802.3dj D2.2

Comment Resolution

Common Track

Introduction

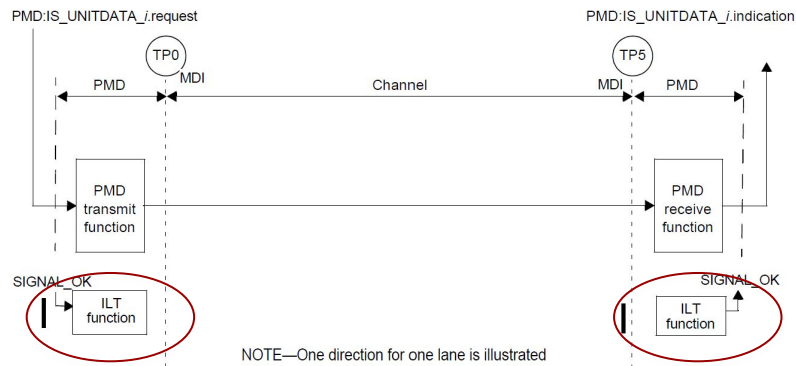
Change:

"for Physical Layer implementations that use the ILT function"

“for service interfaces between interfaces that use the RTS function (see 178B.x)”

Figure 178B-10—Training control state diagram

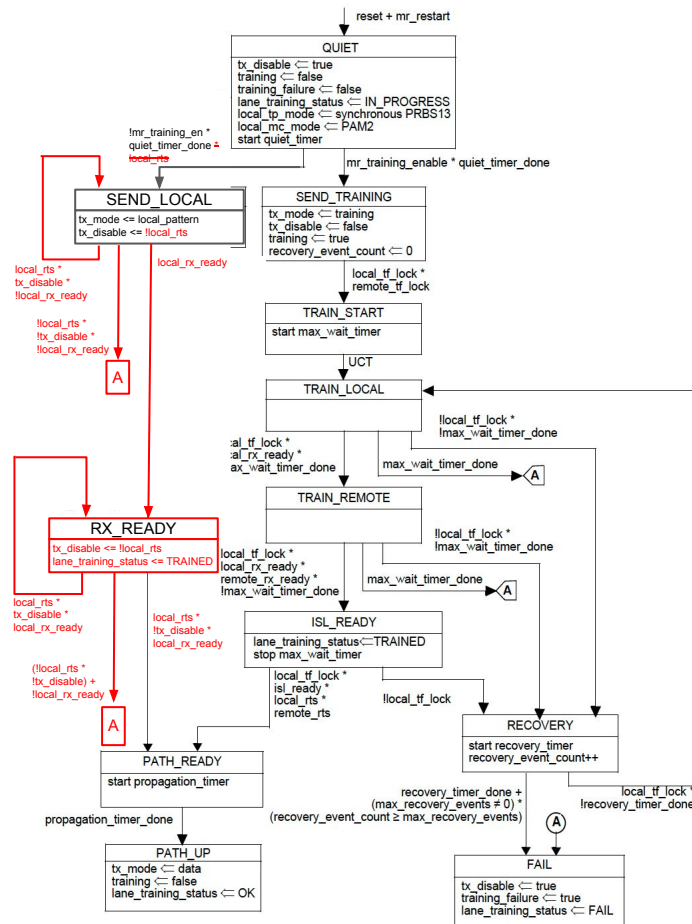
CI 178B	SC 178B.8.3.5	P889	L 10	# 344
Slavick, Jeff		Broadcom		
Comment Type	TR	Comment Status	D	State diagrams (CI)
D2.1 comment #463 brought up an issue with local pattern mode. Nothing was changed in the resolution to address that local pattern mode. A potential fix was supplied on slide 22 of https://iee802.org/3/dj/public/25_09/slavick_3dj_02a_2509.pdf but this may be a larger change than are necessary.				
SuggestedRemedy				
In Figure 178B-10 make the following changes: Remove local_rts as a condition to enter SEND_LOCAL from QUIET Change the assignment of tx_disable to be ~local_rts in SEND_LOCAL add a recirculation from SEND_LOCAL to SEND_LOCAL when local_rts * tx_disable add a transition from SEND_LOCAL to QUIET when !local_rts * !tx_disable Update the transition from SEND_LOCAL to PATH_READY to also require !tx_disable				
Proposed Response		Response Status W		
PROPOSED ACCEPT IN PRINCIPLE. Resolve using the response to comment #222.

CI 178B	SC 178B.8.3.5	P889	L 12	# 222
Ran, Adeo		Cisco Systems		
Comment Type	TR	Comment Status	D	State diagrams (CI)
An apparent issue in the Training control state diagram (Figure 178B-10) is that, if mr_training_enable is false, then lane_training_status can only have the values (IN_PROGRESS, OK, FAIL). It is never set to TRAINED. This means that the interface-level training_status cannot be set to READY, only to OK; the READY value is never propagated across the service interface. This might interfere with the path startup procedure when some of the ISLs have training disabled.				
SuggestedRemedy				
A presentation with more detailed analysis and a proposal is planned.				
Proposed Response	Response Status W			
PROPOSED ACCEPT IN PRINCIPLE.				
Pending review of the following presentation and CRG discussion.				
<URL of presentation>

The changes to Figure 178B-10 on slide 7 of both presentations (shown on the right) addresses both comments.

We propose updating Figure 178B-10 as shown here.

Figure 121-9—Illustration of the mask of the sinusoidal component of jitter tolerance

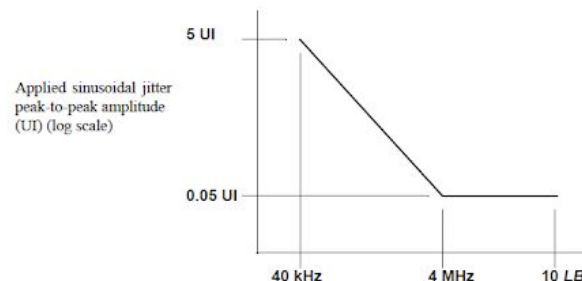
The quality of the jitter tolerance (clock tracking bandwidth) for the TXSEH functional receiver is unbounded. The only constraint is that it complies with (i.e., exceeds) the receiver characteristics in Table 180-8. Care is being taken to properly calibrate the vertical noise but no consideration is given for jitter (horizontal noise). A real receiver is required only to support a clock tracking bandwidth of 4 MHz based on jitter tolerance mask specified in 121.8.10.4. If the TXSEH functional has a tracking bandwidth much higher than 4 MHz then it would permit transmitters with excessive low-frequency jitter to pass.

Specify that the jitter tolerance of the TXSEH optical receiver (ORx) shall minimally comply with the jitter tolerance mask defined in 121.8.10.4 particularly for jitter frequencies 4 MHz and lower.

PROPOSED ACCEPT IN PRINCIPLE.
